UNITED STATES PATENT AND TRADEMARK OFFICE

APPLICATION NO.	FILING DATE	FIRST NAMED INVENTOR	ATTORNEY DOCKET NO.	CONFIRMATION NO.
09/822,154	03/30/2001	Robert A. Immerman	IN0191US (#90067)	6306

Office Action Summary

DETAILED ACTION

Des. 194,307
Patent d Jan. 1, 1963

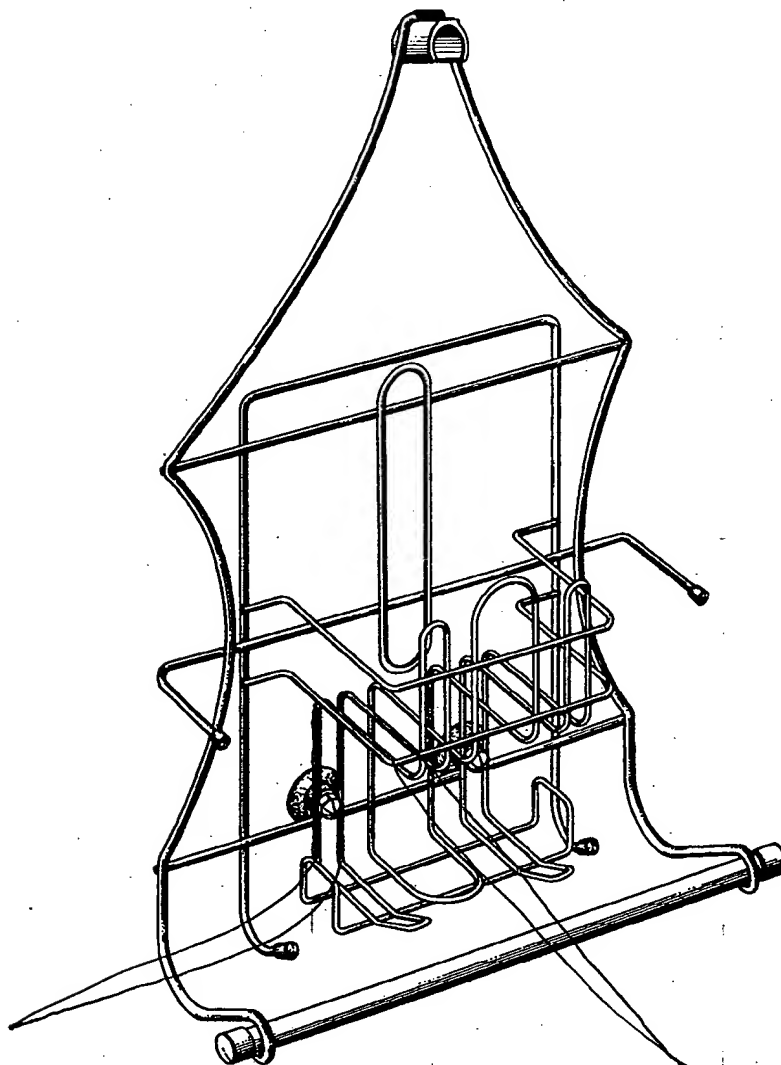
Claim 1,7-9,11,17-19 are rejected under 35 U.S.C. 102(b) as being clearly anticipated by Raphael (Des. 194,307). Raphael shows a first pair of horizontal, generally parallel, rigid wires, a second pair of vertical rigid wires transverse to and

engaging the first pair of rigid wires defining an opening for receiving the head of a suction cup and for retaining the neck in the opening, and a fastening arrangement that holds the second pair of wires attached to the fixture. The suction cup has a compressible head attached to a neck, the neck is attached to an engagement member, the head is insertable into the opening and the neck is retained in the opening.

2 vertical
parallel wires

2 horizontal
parallel wires
